WAAIHOEK WIND ENERGY FACILITY, KWA-ZULU NATAL: TERRESTRIAL AND AQUATIC ECOLOGICAL SPECIALIST ASSESSMENT OF AMENDED LAYOUT

An amendment in the layout and turbine technology and associated infrastructure associated with the Waaihoek Wind Energy Facility refers. The project history and proposed amendments are listed below:

Figure 2 KwaZulu-Natal – Amajuba District CBA map.

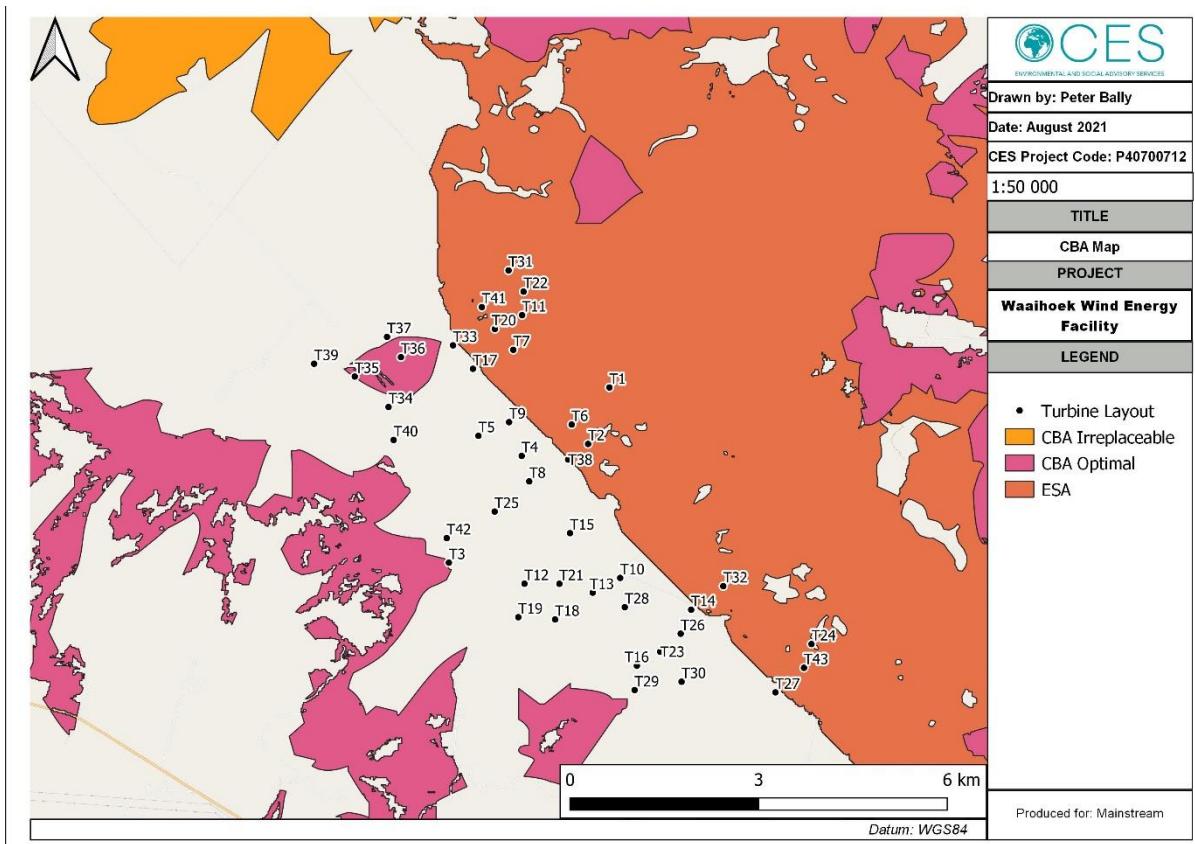
With respect to the amended Waaihoek WEF layout (Figure 2), a single turbine (T36) is located in a 'CBA optimal' and 11 turbines are located within an Ecological Support Area which is known as the Northern Interior Corridor which connects. In the original layout, 3 turbines were located in 'CBA optimal' and 32 turbines located in the Northern Interior Corridor. Recommendations for moving T36 outside of the CBA optimal area and comment on the Ecological Impact of the amended layout on the Northern Interior Corridor is made in the Conclusion section.

<p>The original layout located 3 turbines in what is now classified as a CBA Optimal area.</p>	<p>In the amended layout, one (1) turbine is located in the CBA optimal area. This small patch is clearly demarcated for a particular species feature and even though T36 is placed on an area covered by Black Wattles, the site may (or will) constitute the required habitat for the population. The turbine, therefore, needs to be moved to the following site:</p> 
<p>The original layout located 32 turbines in Northern Interior Corridor.</p>	<p>In the amended layout, 11 turbines are located in the Northern Interior Corridor. This is a favourable amendment towards achieving the goals of the corridor.</p>

Figure 3 Wetlands in the study area of the Waaihoek WEF.

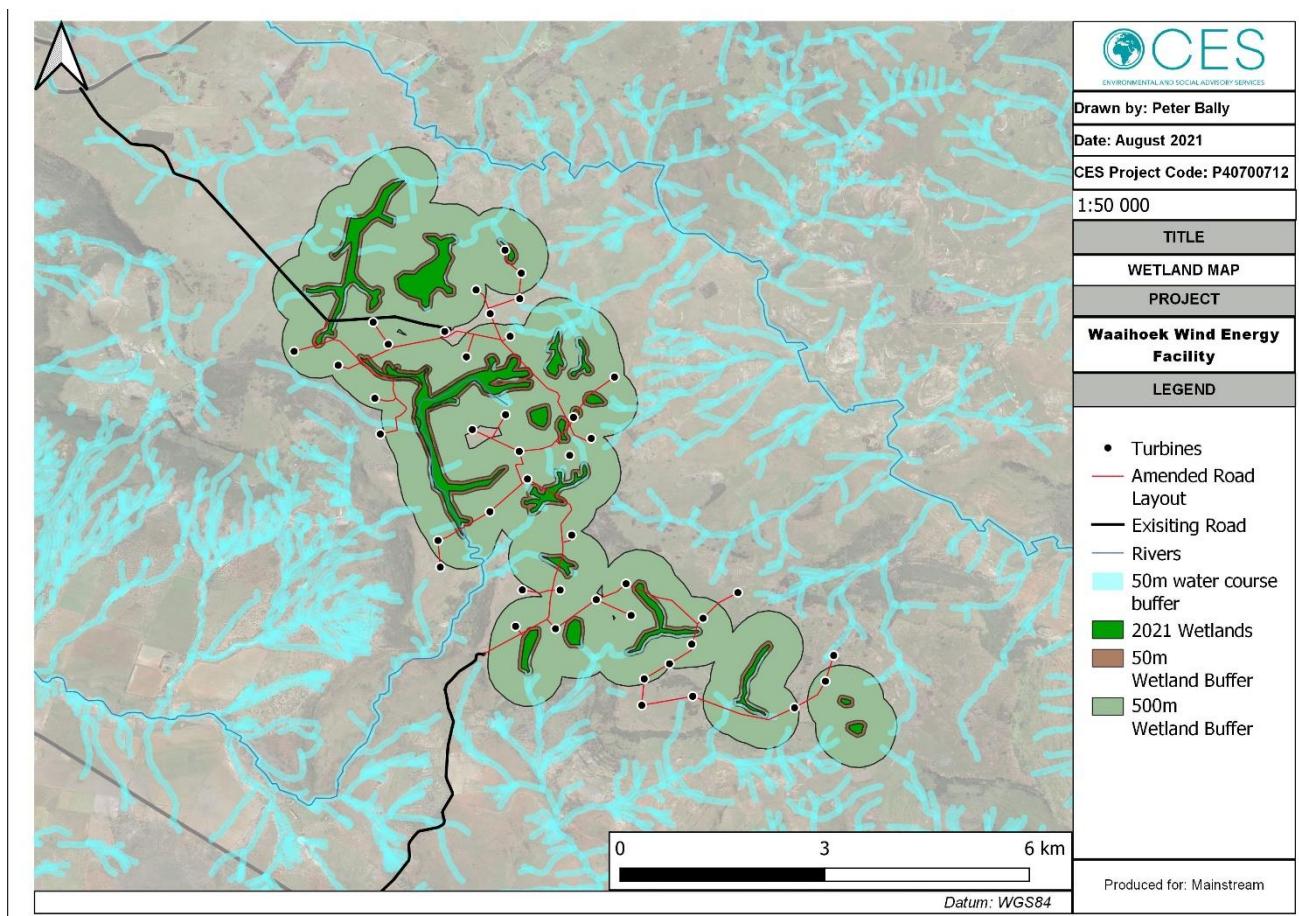
The wetland layer developed in 2013/14 has been updated and revised in this assessment based on the Wetland Inventory V5 (Wet5, 2019) and digitising from Google Earth Pro aerial imagery. A number of additional wetlands, which were previously indicated as water courses, have been incorporated into the wetland layer (Figure 3). No turbines are located within a wetland, but most fall within the 500 m buffer, for which WULAs will be required.

It is also important to note that all the slope-wetlands in the study area that were delineated in the Wet5 layer were assessed as **CRITICALLY ENDANGERED (CR)**, and depression wetlands as **LEAST CONCERN (LC)**. Only one wetland is considered as a depression wetland and, therefore, by extrapolation, the wetlands delineated in this report have been classified as Critically Endangered. Recommendations for micro-siting turbines and re-routing the access roads and cables are made in the Conclusion section.

Development activity	2021 Assessment of impacts on wetlands
Turbines and wetlands	No turbines are located in any wetlands, however some are still within 100 m. Minor micro-siting of the turbine layout needs to ensure that turbines are outside of the 100 m buffer. This should be conducted through the WULA process and will be subject to conditions of the WUL, the process of which will determine the impact risk to the respective wetland.
Access roads and underground cables and wetlands.	Numerous recommendations to realignment of the road (and hence underground cable) have been provided (Figure 4). The realignment recommendations seek to avoid crossing wetlands. There is one instance (T13-T14) where an existing track is routed through a wetland/water course (see insert below). This assessment proposes that the existing track (green line) is used instead of constructing an additional road upstream of the same wetland (red line) to prevent cumulative impact and degradation of the wetlands/water course. It is also a recommendation of this assessment that the wetland crossing is formalised and designed to minimise impact on the wetland.
